DOCKETED	
Docket Number:	19-SPPE-04
Project Title:	SJ2
TN #:	241458
Document Title: Ada E Márquez Comments - CEQA Comment Letter On Evidence of Significant Environmental Impacts (1 of 4)	
Description:	N/A
Filer:	System
Organization:	Ada E. Márquez
Submitter Role:	Public
Submission Date:	2/7/2022 4:02:24 PM
Docketed Date:	2/7/2022

CEQA Comment Letter On Evidence of Significant Environmental Impacts

Re: Draft Environmental Impact Report (DEIR) for the San Jose Data Center SCH # 2021020002 (SJDC or Project) (Docket Number 19-SPPE-04)¹
Applicant Microsoft Corporation- Small Power Plant Exemption (SPPE)

Figure 11: The Microsoft SJDC Project includes the footprint of 64.5 acres and areas of infrastructure improvements. (Source: BAAQMD, Map created by Márquez, 2022)

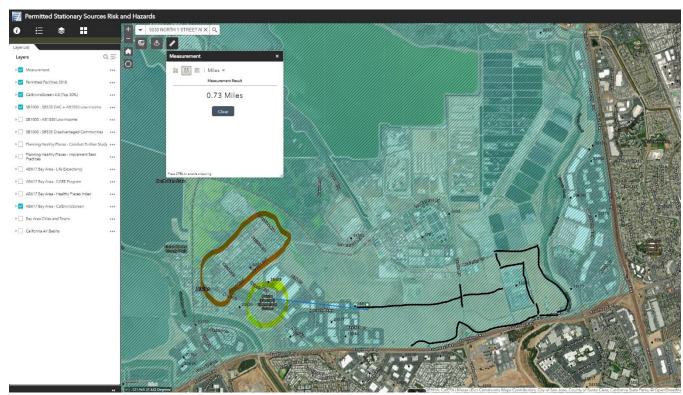
The applicant used only the project footprint to measure the outside 1,000-foot zone of influence for environmental impact analysis. Per §15126 "all phases of a project must be considered when evaluating its impact on the environment: planning, acquisition, development, and operation". The impacts from offsite infrastructure improvements areas to sensitive receptors must also be included in the air quality analysis. As documented in the CEC Docket, Alviso residents expressed numerous concerns about the impacts to the George Mayne Elementary School and residential area of Alviso (Figure 11). The applicant must include the Alviso community's sensitive receptors which are located within the Alviso Master Plan. To fully disclose the cumulative impacts within Alviso, the CEC Staff must provide a map with different sizes of radius, for example at 500 feet, 1,000 feet, 1,500 feet, 2,000 feet, etc.

Figure 12: The primary project entrance for the Microsoft SJDC Project to George Mayne Elementary School (Source BAAQMD, Map created by Márquez, 2022).

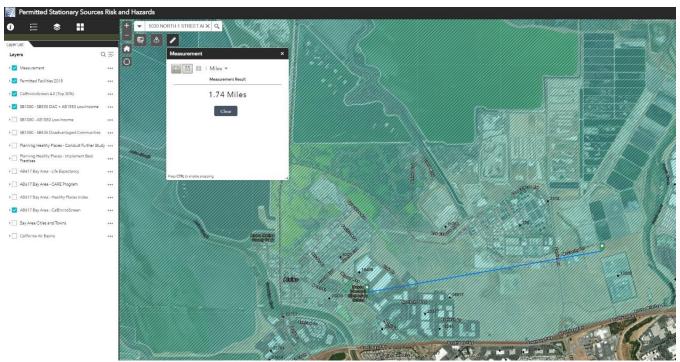
- (c) Substantial adverse effects on human beings, either directly or indirectly: The CEC Staff omitted the Project's environmental and health impacts to the Alviso community. The DEIR did not consider the children's health at George Mayne Elementary School and the future attendance at Santa Clara Unified School District's Agnews East School Campus Project SCH# 2018032018, located at 3500 Zanker Road, San Jose, CA. The HRA must be revised with the most current HRA guidelines. On behalf of the Alviso community, the CEC Staff should contact the experts at the BAAQMD (APPENDIX D) and CARB for air quality analysis.

Figure 13: The applicant's modeling provided by Jacobs (TN# 240407), p.4 and (TN#240082), p.5 (2021) .

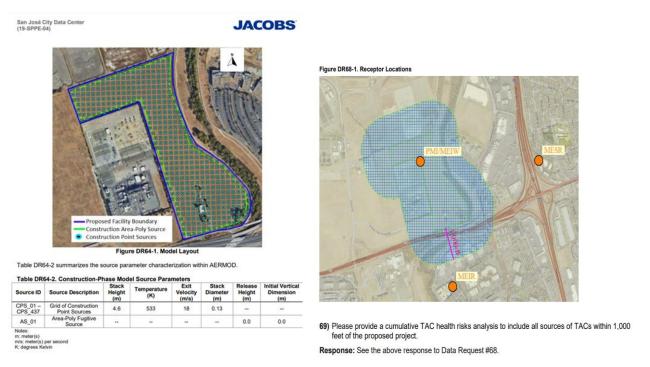
- The modeling assumptions for construction workers and the location of sensitive receptors are erroneous. The impact analysis must also include the community of Alviso and George Mayne Elementary School. The analysis did not disclose and analyze the truck routes for construction and project operations, and of the tanker trucks when refueling the backup generators at the SJDC (Figure 13).

Figure 14: The yellow highlighted area was not included in the air impact analysis by the CEC Staff.

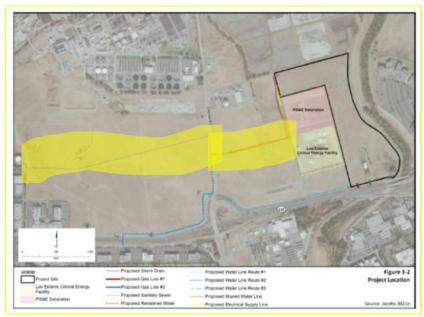
- The CEC staff did not include an analysis of impacts to sensitive receptors within 1,000 feet of construction activity, the truck routs, and location of equipment for staging areas for the offsite infrastructure improvement areas.

Figure 15: Areas within Alviso need to implement Best Practices per BAAQMD (Map by Marquez, 2022).

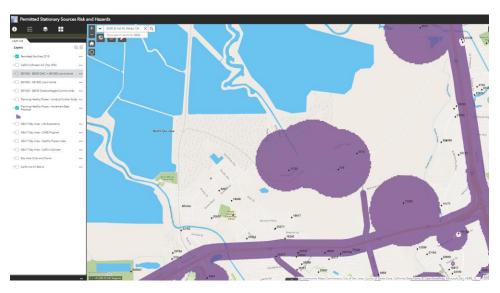
- To provide power to the Project, it will have two new 115 kV underground 1,100-foot-long cables that will connect from the new SJDC Substation to the existing Los Esteros Power Plant Facility, the HRA must analyze the health impacts of existing conditions plus the proposed Project (Figure 15).
